STAFF REPORT

PLANNING & ZONING COMMISSION

1. FINAL DEVELOPMENT PLAN

Applicant: Chris Bradley/The Camber Company
Location: 185 N. Liberty Street
Existing Zoning: Downtown Residence District (DR)
Request: To review a proposed single family subdivision consisting of 21 residential units on 5.38 acres.

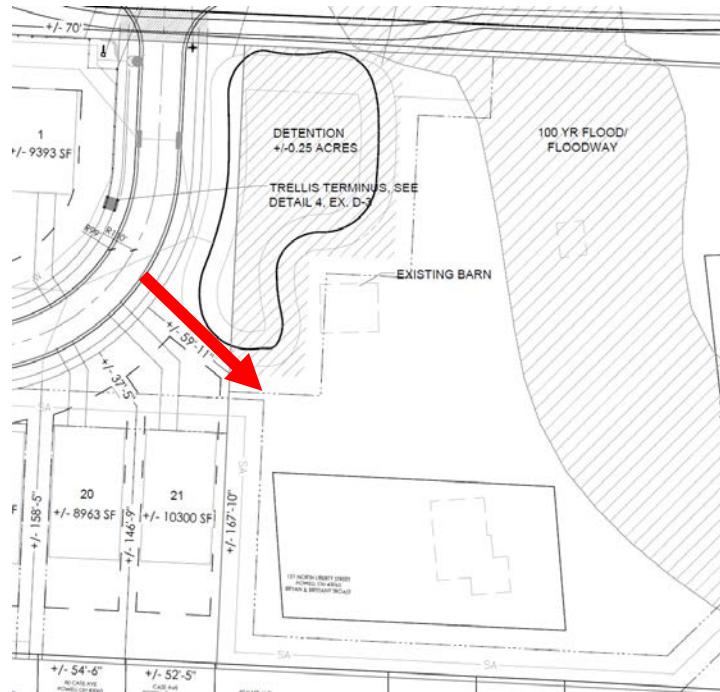
The proposal will not have a negative impact on planning or zoning surrounding lands. In actuality, once completed with the stub road, the proposal will help to plan the surrounding uses in a more complete way – by providing access. This is not only true for the parcel to the south but also for the parcel to the east. A common access drive (CAD) has been earmarked for possible future development of the site (see image below).

- 1) All Engineering Department requirements are met.
- 2) The CAD for the property to the east is noted on the plan and plat.
- 3) Dedicated lands are noted on the plan and plat.
- 4) Being custom homes, detailed architectural selections (colors and materials) are reviewed by Staff before construction of the homes.
